REGULAR CITY COUNCIL WORK SESSION MEETING January 08, 2024 9:00 AM City Hall

**SUBJECT: 257 Business Park** – Preliminary Plat

Case Number: 23.08 FSP

## **257 Business Park**

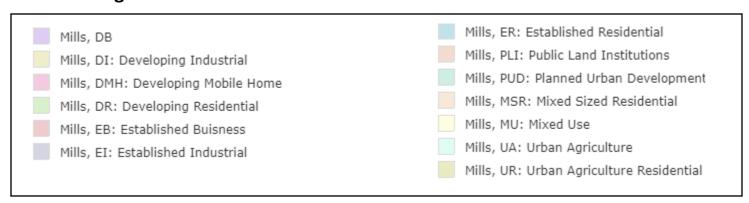
- 1. Section 17.18.020(i) of city code provides the following: "The town shall adopt and enforce standards for subdivision layout, street construction, water and sewer system construction and storm sewer construction, as deemed necessary to promote the health, welfare and orderly grown of the town (Ord 274 §2 (part) 1979).
  - a. The City of Mills has adopted by reference, and long applied in practice, the City of Casper Design Standar Tor Public Works Construction and

- Infrastructure Improvements (Chapter 16.16).
- b. Per 16.16.060, the minimum right-of-way/access easement width for a local street within low density development is 50'.

- 2. Receive an approved Access Permit from WYDOT for the approaches off HWY 20/26 and HWY 257
  - a. Comply with all requirements of the WYDOT access permits

- 3. Add road names to all streets within the subdivision
  - a. The access between Lots 1 & 3 should be named Chapman
  - b. Provide a name for the access between Lots 1 & 2

- 4. Submit infrastructure plans, including:
  - a. Water distribution system plans
  - b. Sewage collection system plans
  - c. Road plan, profile and construction drawings

- d. Drainage plan
- 5. Discuss plans for construction of subdivision infrastructure, including roads and water & sewer infrastructure.
  - a. Timeline for Permit to Construct

- 6. All cul-de-sacs shall have a diameter of no less than 96'.
- 7. Delineate the drainage easement on one of the lots, instead of showing it as its own parcel.

- 8. Survey Review:
  - a. Add State Plane Coordinates, northing, easting, elevation, Convergence and Combined Factor to two (2) of the exterior corners.

- b. The coordinates are in grid but the distances are in ground
  - c. Verify the north corner(s) of the plat and Lot 1. Review Instrument #866007 as excepted in Instrument #1143765, with regard to the WYDOT parcel.

- d. There is a mis-closure of Lot 4 by 1.63 feet
- 9. Cosmetic Revisions to the Plat:
  - a. Add TO THE CITY OF MILLS under "Plat of 257 Business Park" in the title block on both plat sheets.

- b. Make the adjacent subdivision and road names gray.
